Design Principles

6.2 OFFICERS COMMENTS

6.3 RETENTION VIABILITY

Proposed elevation drawings from initial pre application document (now superseded)

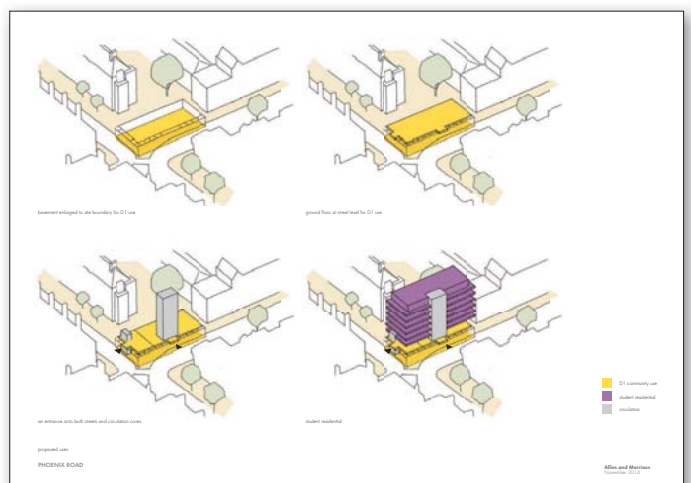
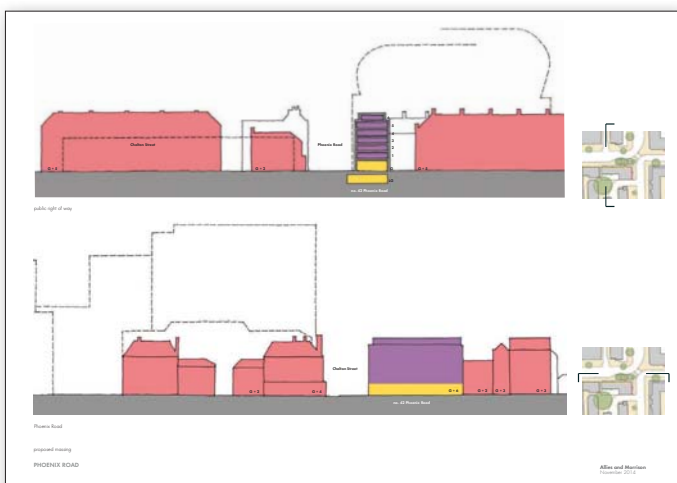
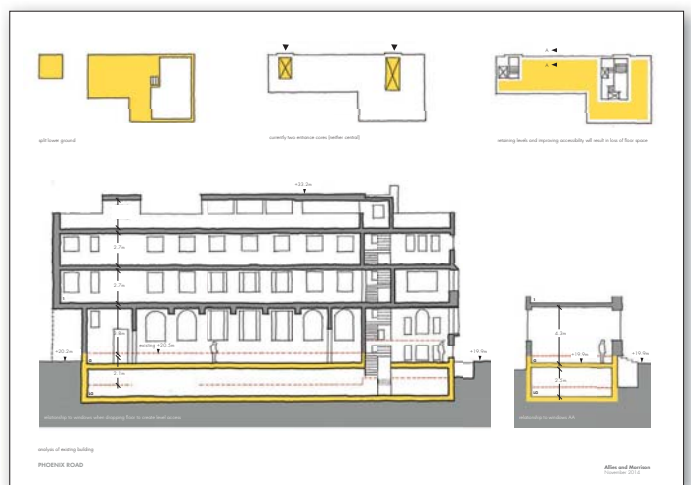
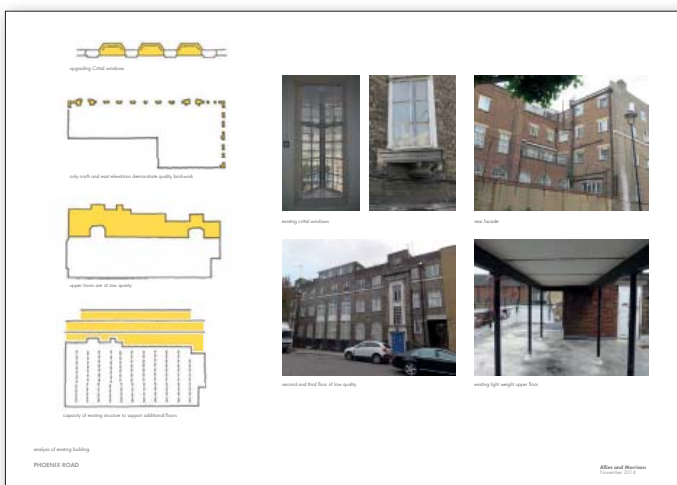
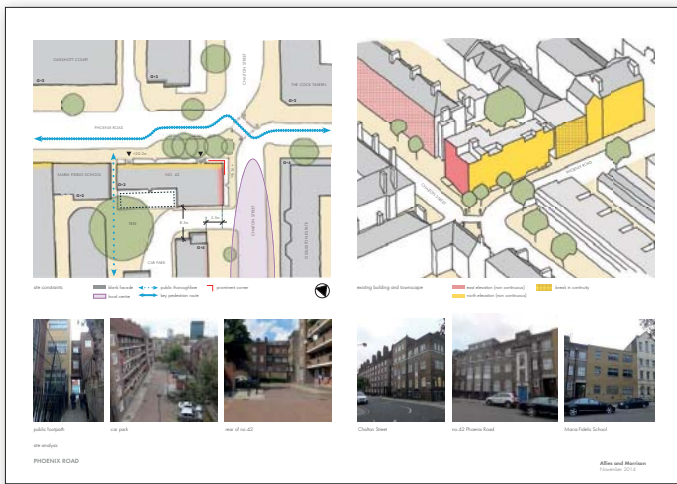
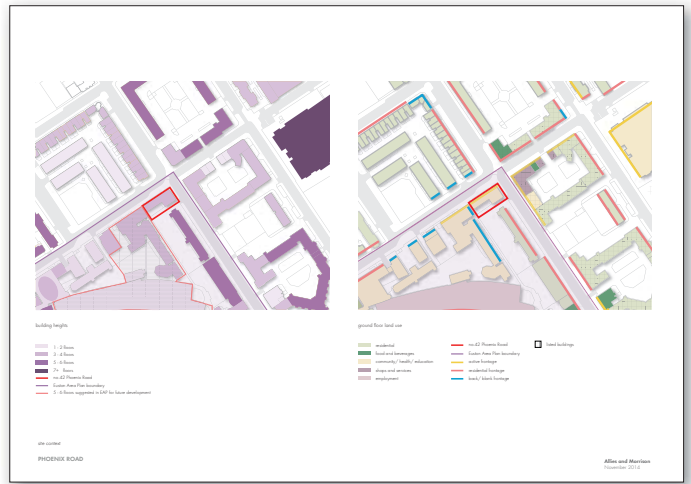
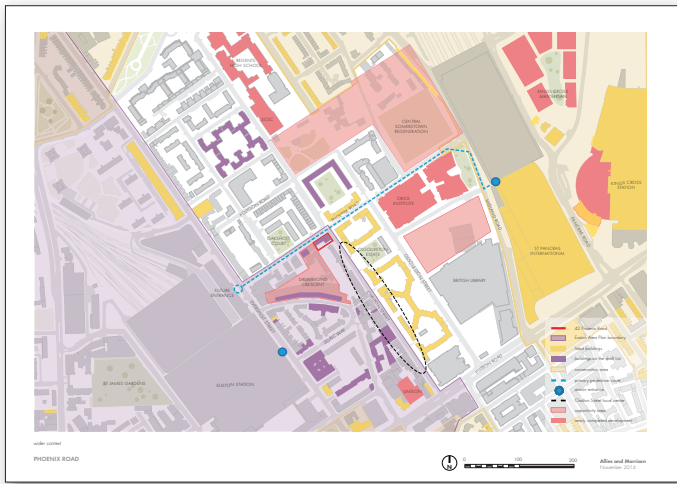
In addition to the issue of the local list, some feedback was given on the scale and character of the proposed building. At 7 storeys tall and civic in its character, the proposal was considered to be inappropriate for this location.

- **Proposed replacement building is alien to its surrounding in terms of height, scale massing and the resulting building would have a dominant impact on the street scene**
The proposed height would result in an overly dominant impact on neighbouring residential occupiers

These comments were based on the initial Simon Corbett proposal for a 7 storey building. A&M have since reduced the proposal to ground + 5 storeys with a set back roof at 5th floor level. A&M have carefully considered the scale of the proposal to be in keeping with surrounding development in form an character

3D view of Option One

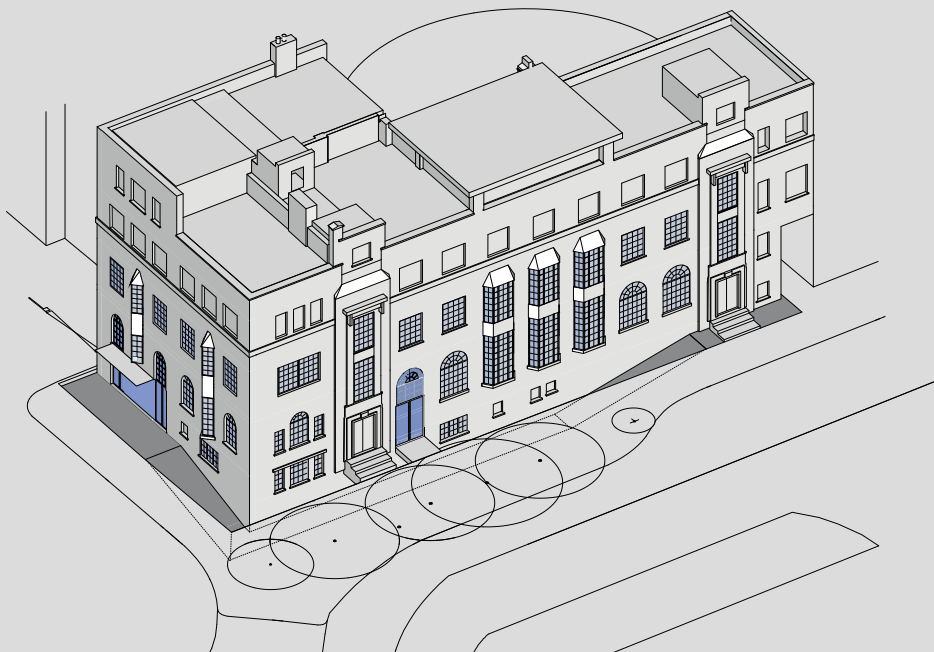
Does this option provide usable spaces?

No. These interventions would substantially reduce the usable D1 floor space within the building at ground and lower ground floors. The introduction of the lift to service student residential floors would also reduce the upper floor efficiency.

The blocking up of windows and external door at lower ground floor will reduce the natural light to unacceptable levels and likely contravene fire regulations regarding means of escape.

Does this option retain the façade unaltered?

No. These interventions would require removing a large arched window onto Phoenix Road, opening up the façade to install a new street level entrance via a bridge across the lightwell, and blocking up of the window and door below. Plus the removal and blocking up of two street level windows onto Chalton Street, removal and extension of two arched windows and opening the façade to install a new street level entrance.

Is this option viable?

No. Assuming the existing building could cope with such significant structural alterations, the substantial costs involved in cutting out two sections of the reinforced cast in-situ concrete floor slab, their reconstruction at street level, corresponding lowering of window sill heights, removal of internal structural walls, installation of two passenger lifts and four staircases, together with the myriad of environmental upgrades required to meet modern building regulations are exacerbated by a significant reduction in the net lettable area within the building.

This option is structurally difficult to undertake and correspondingly extremely expensive. The work would result in a substantial loss of D1 floor area across the lower three floors and the remaining space would be less efficient and more congested due to the installations of new stairs and lifts.

It is clear that such an option would be wholly unviable in both economic and planning terms. The existing façade to both Phoenix Road and particularly Chalton Street would be altered so as to warrant the building's likely removal from the local list and there would be positive harm to the streetscape and local community.
